**Historical Architectural Review Board
COA Preliminary Review Sheet**

HDC-2024-00085

Address: 953 Turner Street

Proposal: Remove deteriorating fence and shed and grade-level deck and create 2-car parking pad with apron.

Shed to be Removed (Applicant)

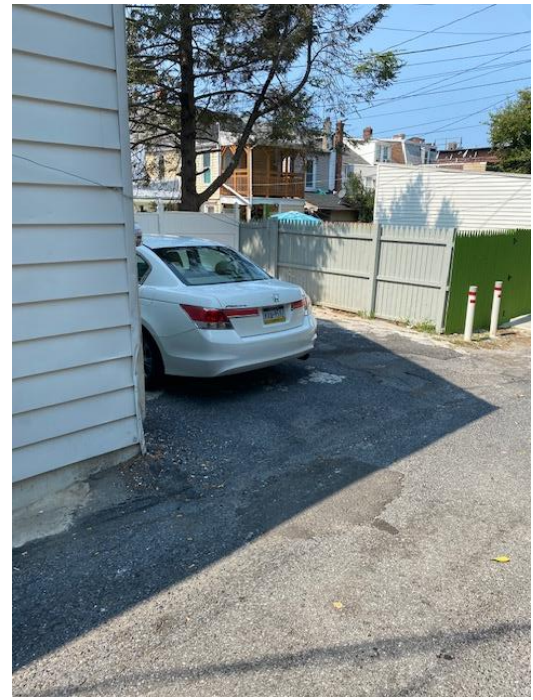
Observations & Comments: The existing shed and fencing proposed to be demolished are not historic and not contributing to the historic district. The application does not indicate if any fencing is to be installed after the proposed work. Staff note that if a fence is to be installed in the future, the applicant should submit the design and material of the fence to be reviewed by staff.

Mr. Jordan summarized that the deck is outside HARB purview. The shed is not historic, and no board members raised concern about its removal. Discussion continued for the demolition request for the fence. There was no evidence in the application materials or Sanborn Maps that the proposed fence line to be demolished is a historic street wall. Mr. Jordan acknowledged that half and quarter streets play an important role in an historic district's urban integrity. Mr. Encelewski stated that if any future property owner does not desire a parking pad, they would be likely to install a replacement fence to enclose the yard. Mr. Franzone noted that the demolition of the fence should be allowed, given the absence of proof of a historic street wall.

Staff Recommendation: Recommend approval with the following condition:

- If a replacement fence is to be installed, refer to Guidelines Section 3.12 and submit design and material of replacement fence.
